Tyrone Operations
P.O. Drawer 571
Tyrone, NM 88065

March 9, 2011

Re: **Responses to Comments on the Tyrone Mine Waiver**
Modification Application of July 2010, GR010RE, Revision 10-1

Drawn		MWH	<div> FREEPORT-McMORAN COPPER & GOLD</div> <div>TYRONE MINE Figure B-4 Mine Production Impact - Cross-Section</div>	Scale:
Designed		MWH		Dept.
Checked		TLS		
Date		03/07/2011		Rev.
Job No.			0

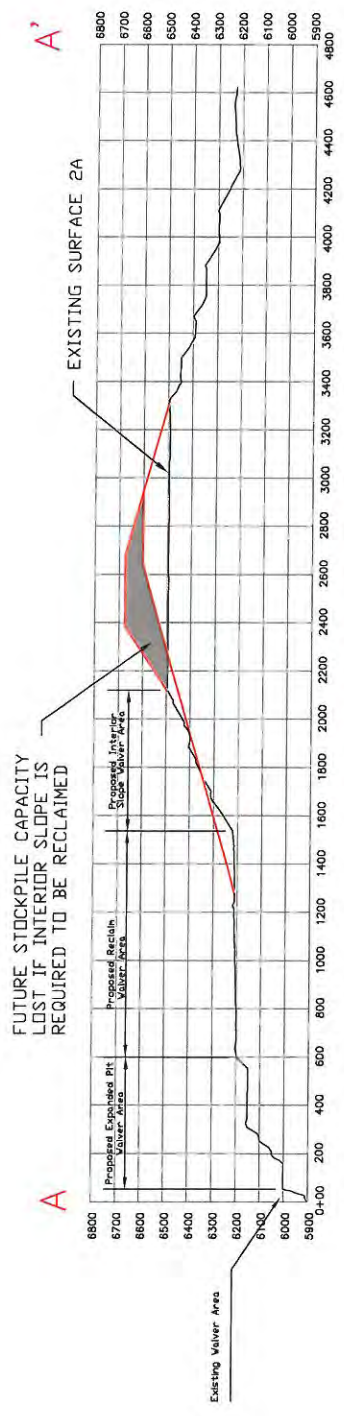
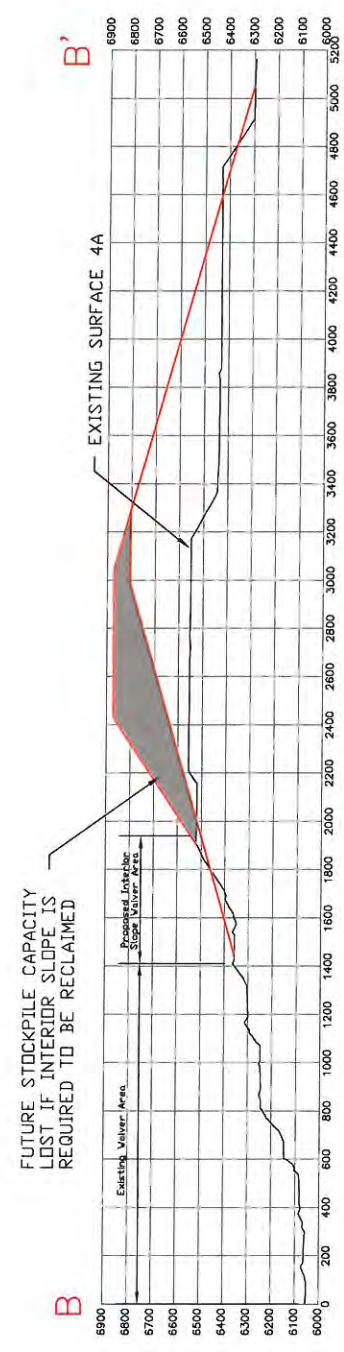
MMD Comment 2 *Section 2.2, Economic Infeasibility of Interior Stockpile Slopes, pages 9-10 of the application – Tyrone provided information regarding the economic loss due to reduction of storage volume, summarized in table 2.2.2, and in Attachment B, Tyrone Mine Life/Economics Information. During the 2/1 meeting, Attachment B including Figures B-1, Mine Production Impacts, and Figure B-2, Cross Sections Illustrating Lost Interior Stockpile Capacity were discussed, and Tyrone indicated that it would provide additional information including drawing(s) and cross sections that would further clarify Tyrone’s description of future stockpile configurations based on the comparison of 3H:1V slopes to “angle of repose” slopes.*

Tyrone Response 2 The attached Figures B-3 and B-4 illustrate the concept of lost storage space more clearly. Figure B-3 indicates the position of the two cross sections relative to the Tyrone mine features. Figure B-4 shows cross sections through Stockpiles 2A and 4A similar to those provided on Figure B-2 in the July 2010 application. The interior of the mine is on the left side of the sections. The highest elevation red line is the profile that could be obtained with a waiver (no interior slope reclamation) and the lower elevation red line is the profile that would be necessary if the interior stockpile slope is to be reclaimed. The loss of storage space is indicated by the shaded gray color. Tyrone has also indicated the extent of the July 2010 waiver request on the sections on Figure B-4. Tyrone trusts that these new cross sections adequately clarify the questions raised by the MMD reviewers.

Drawn Designed Checked Date Job No.	MWH	TYRONE MINE Figure 6-Pit Rim Water Management Conceptual Drawing 2C Stockpile Interior Slope	Scale:
	MWH		Dept.
	TLS		Rev.
	03/07/2011		0

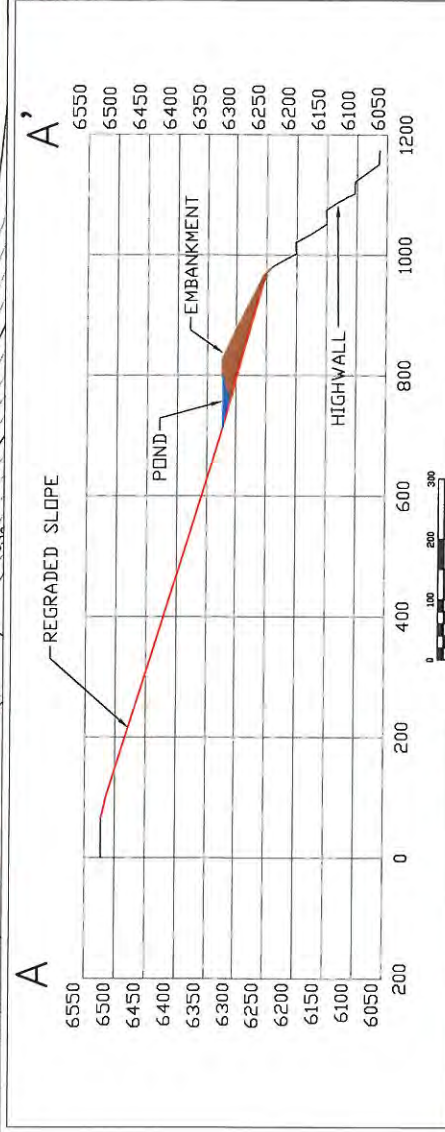
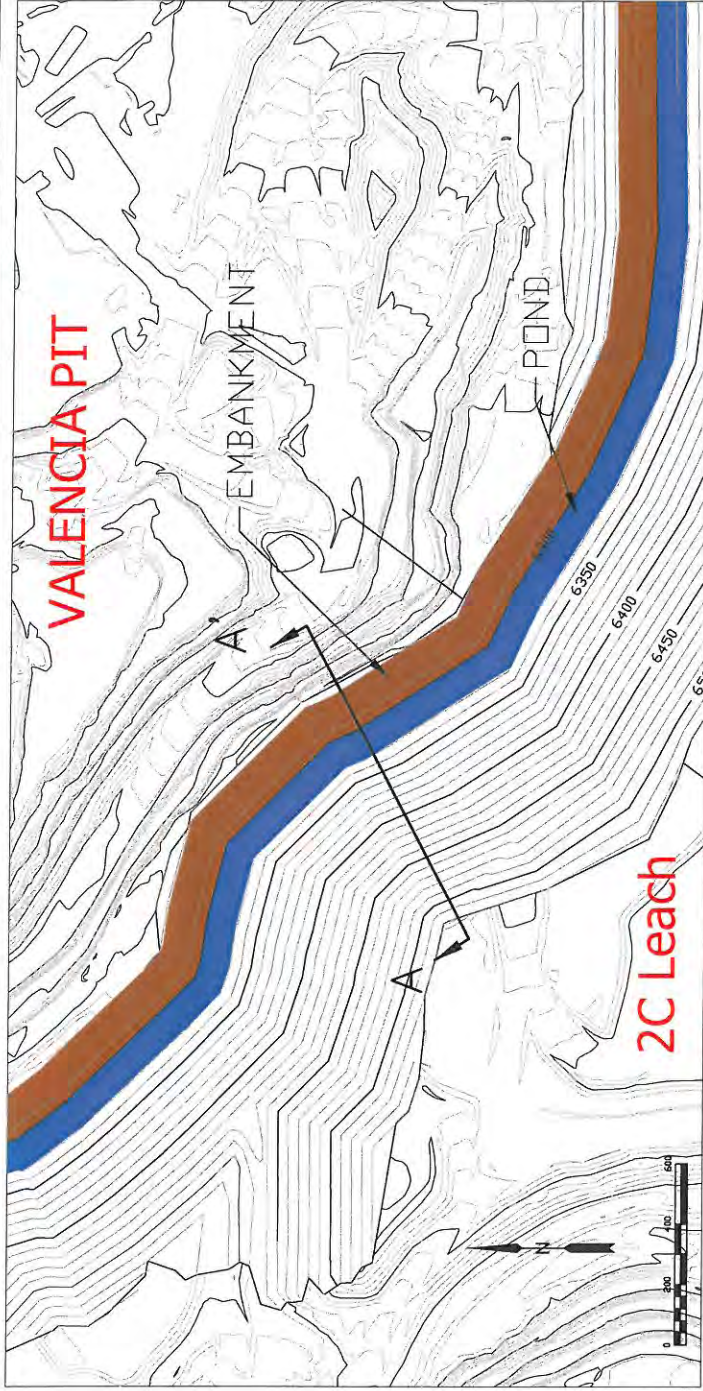
MMD Comment 3 Part 1 *Section 2.3, Environmental Unsoundness of Stockpile Sloping, pages 10-11 of the application – During the 2/1 meeting, Tyrone discussed how the requirement to reclaim the interior slopes of the stockpiles to a 3H:1V slope would likely cause difficulties on stormwater management and handling that could result in a less environmentally sound situation at the mine than if a waiver from regrading the was approved and the interior slopes of the built-out stockpiles were to be left at “angle of repose” or approximately 1.5H:1V. Tyrone indicated that it would provide a more detailed discussion of this issue in support of their waiver modification application.*

Un-impacted water must be routed, collected and moved physically by pumps and pipelines to discharge into natural drainages outside of the mine area (achieving the same environmental result as a perimeter slope that discharges by gravity to a perimeter natural drainage). Construction of these water management features will require the creation of a complex network of multiple holding ponds/containments designed to handle large design storm events. In most cases (1A, 1B, 2B, 2C, 3B, 4A, portions of 5A, 6B and 6C) there is little to no space between the toe of the stockpile and the rim of the Pit to construct sufficient pond capacity in a location where they could be completely effective and safely managed. Figure 6 illustrates the lack of real estate to construct a stormwater containment berm along the reclaimed toe of the interior slope of the 2C Stockpile in order to segregate the fresh water runoff and pump it to a natural drainage on the perimeter of the mine. In this example, the containment for the runoff water would have to be constructed above the reclaimed stockpile surface. If the pond were to overflow in a large storm event or if the containment failed for other reasons, it would create a large concentrated flow that would cause great erosional damage and pit highwall instability. The erosional damage would be much more significant than the incidental erosion that we experience at the mines near the interface of pits and surrounding stockpiles now, even during large rain events. These containments would have to be maintained for very long periods. There is not a suitable location where water containment could be sited and managed to avoid potential slope and pit wall stability issues. Tyrone maintains that this is an environmentally unsound management practice for closure.

Leaving the interior slopes at a steep angle allows more of the stockpile top surface runoff to drain toward the exterior of the mine by gravity where it can be practically managed. Regrading the interior slopes to a flatter configuration for reclamation causes more runoff water to drain toward the pit.
